Committee Scheme - Building 08 Ground Floor Plan

Proposed Scheme - Building 08 Ground Floor Plan

2.5 Building 10

Proposed Scheme - Building 03 Ground Floor Plan

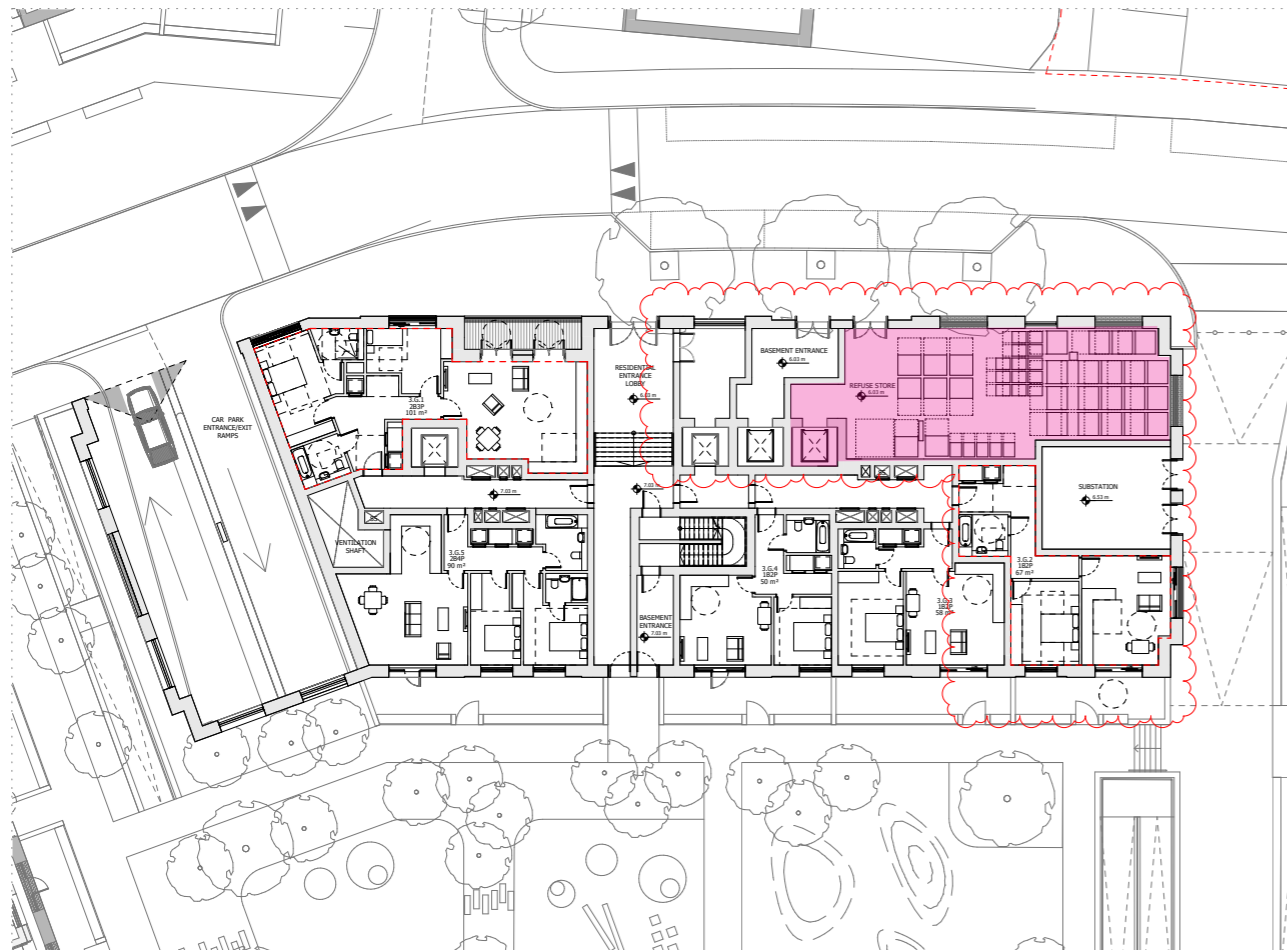
Building 03 is under 18m so no changes are required to the core layouts to accommodate extra staircases. However the updated refuse strategy has resulted in larger collection store required on the ground floor of B03 which has had knock on effects to the location of the substation and some of the ground floor residential units.

These changes have resulted in the loss of 1 habitable room at ground floor and 1 wheelchair accessible unit has been replaced by a typical unit. There are no changes to the upper floors of Building 03.

Proposed Scheme - Building 01 Ground Floor Plan

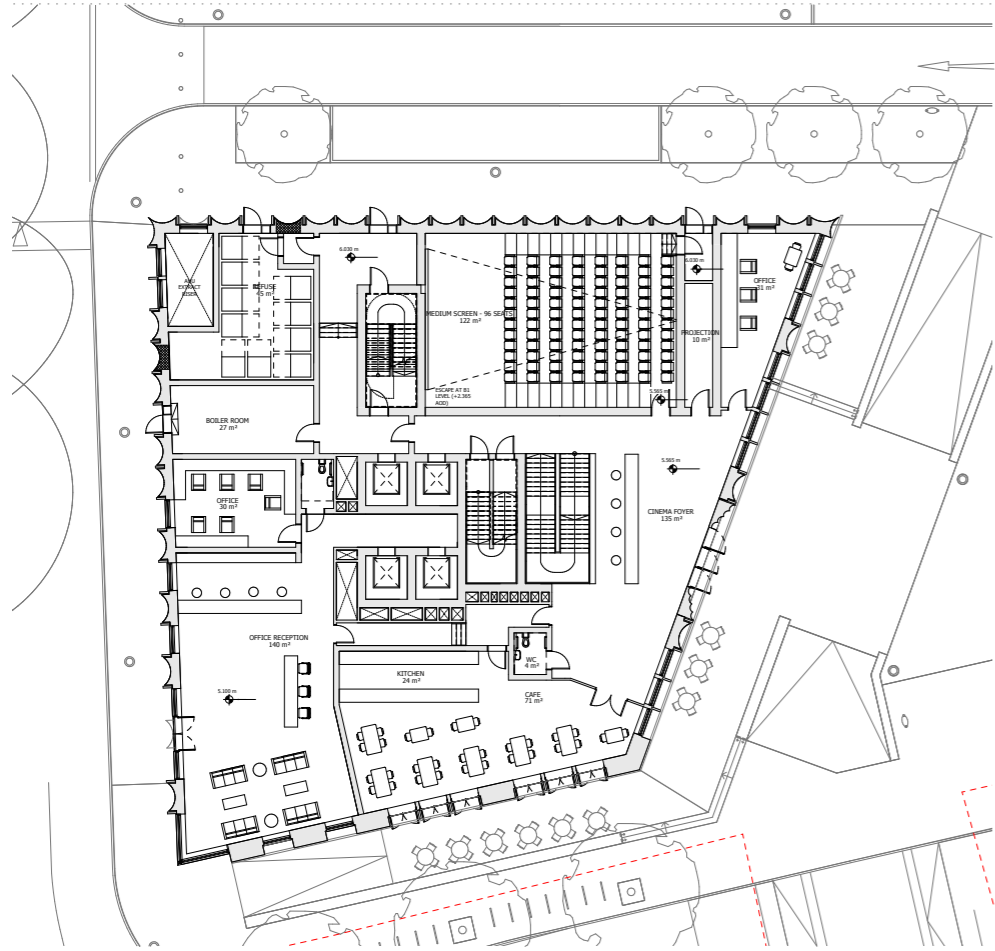
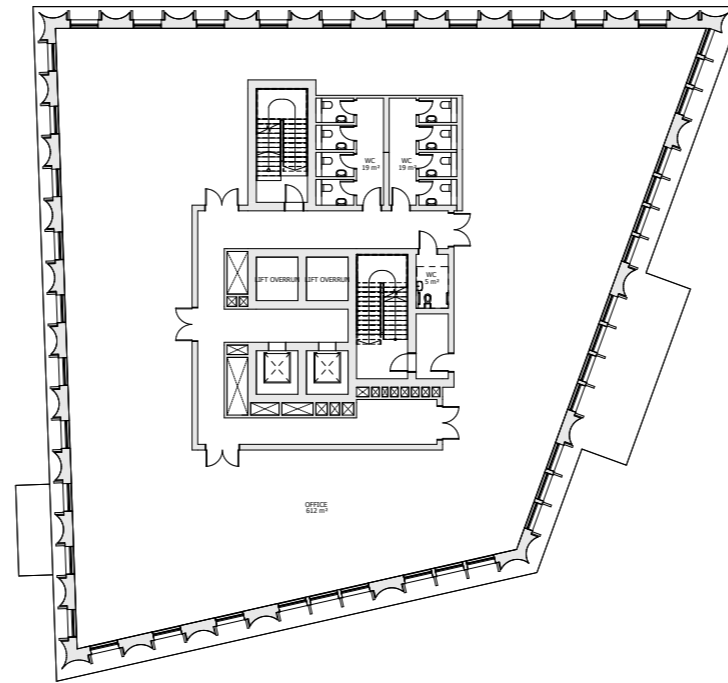
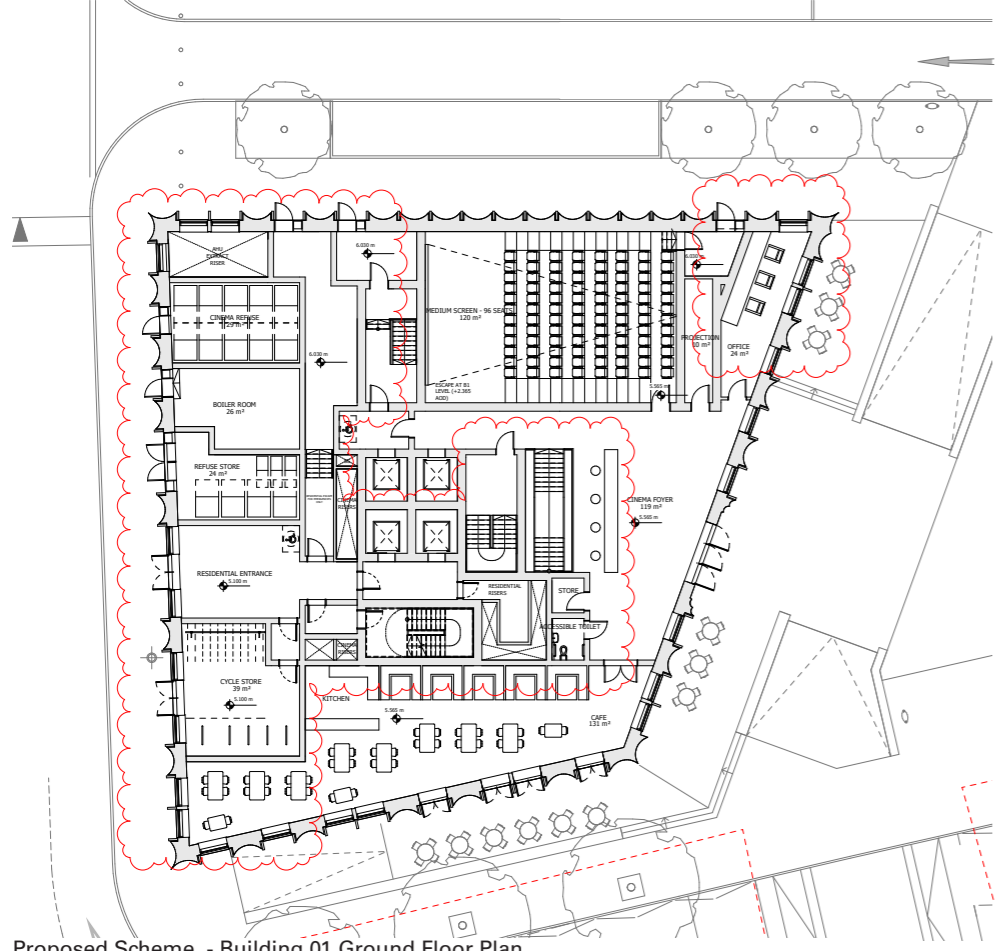
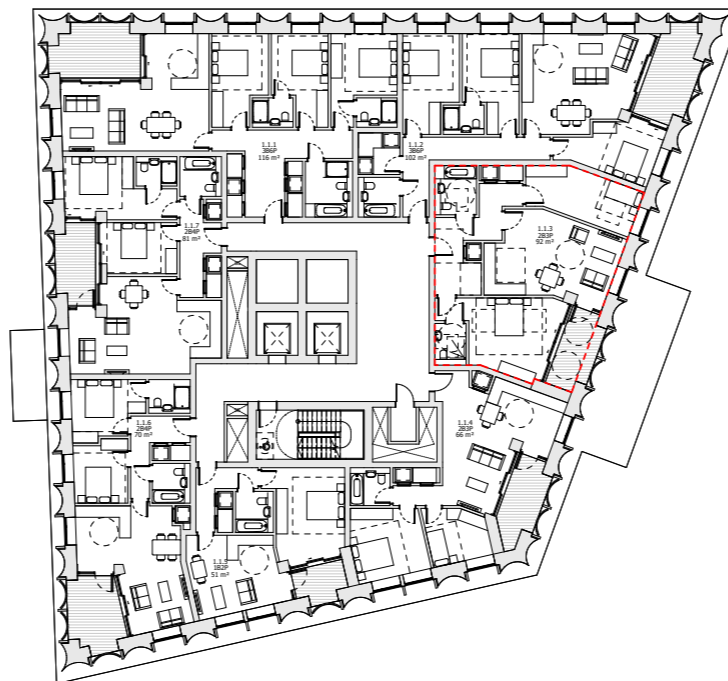
The committee scheme proposed Building 01 as cinema use at ground and 2 levels of basement with 3 levels of office above. These scheme amendments propose to replace the 3 levels of office with residential accommodation to replace residential NIA lost from other buildings across the development due to the fire-led changes.

The 2,571 m² GIA of office is replaced by 2,081m² residential with 17 units which are a mix of 1,2 & 3 beds.

The layout of the cinema has only undergone minor changes to suit the addition of the residential core, entrance, cycle and refuse stores.

Proposed Scheme - Building 01 East Elevation

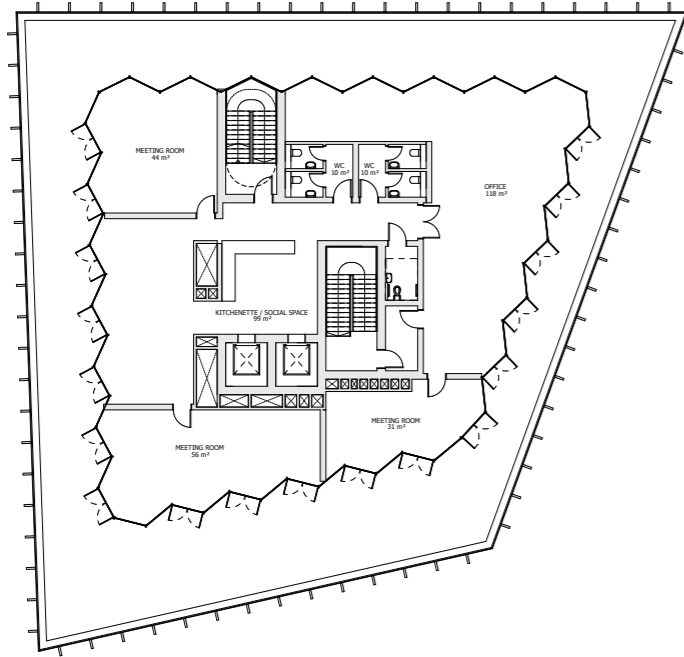
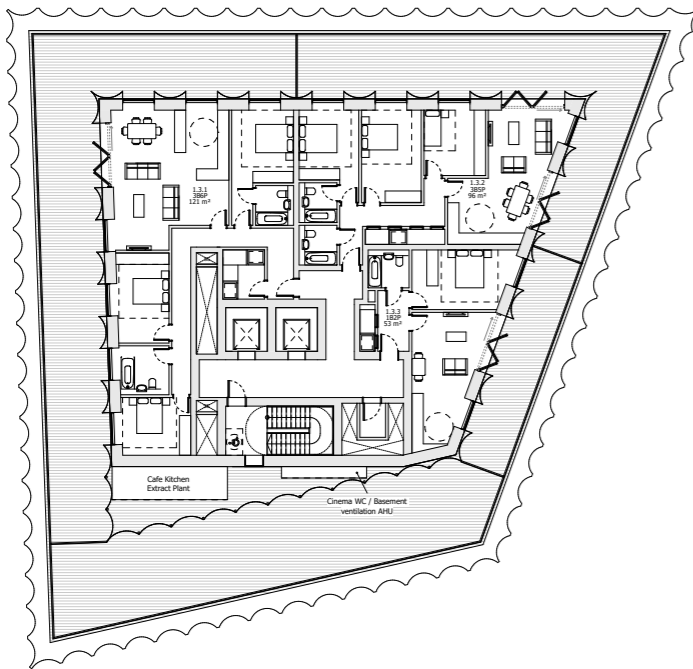
These scheme amendments aim to keep the design intent of Building 01 as similar as possible to the committee scheme, however some minimal changes are required to suit the change in use. Inset balconies have been introduced to the 1st and 2nd floors. The location of windows has been changed to suit the internal layouts, which is carried down to the ground floor. The residential windows are also now openable. The 3rd floor, which is set-back from the floors below, was previously proposed to be glazed which would not suit the new residential use so these amendments propose bronze metal cladding with the same fluted language as the precast below.

The overall height of the building has reduced by 1.6m due to the reduced floor to ceiling heights required for the residential floors.
